ECE/TRANS/WP.29/GRRF/2008/25
28 August 2008

REGULATIONS Nos. 13 AND 13-H (Braking)

Alignment of Regulation No. 13 with 13-H

Proposal for draft amendments to Regulation No. 13
(Braking)

Figure 1. The test layout, showing prevention of wheel rotation and application of side load

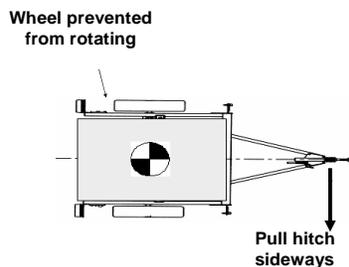
8.2. Prevent one of the wheels from rotating to ensure that the brakes on only one side of the trailer are forced to operate in the reverse direction (see figure 1 below).

Following this test, the parking brake should be released and the brakes re-settled prior to repeating the test on the wheel(s) on the other side of the axle(s) with the test layout requirements reversed.

8.2.1. Any resistance from the jockey wheel shall be removed as far as is practicable and the minimum load as calculated in paragraph 8.4. is applied at 90° to the tow-hitch

in the direction opposite from the side of the trailer to where the wheel(s) are prevented from rotating.

8.3. The load is increased until the trailer starts to rotate or the minimum force is reached. The method of applying the load to the tow hitch must ensure that there is no reduction in the gradient simulation force, even when the trailer begins to move. The limited movement typically 50 mm associated with the operation of the auto-reverse mechanism is ignored in this respect.
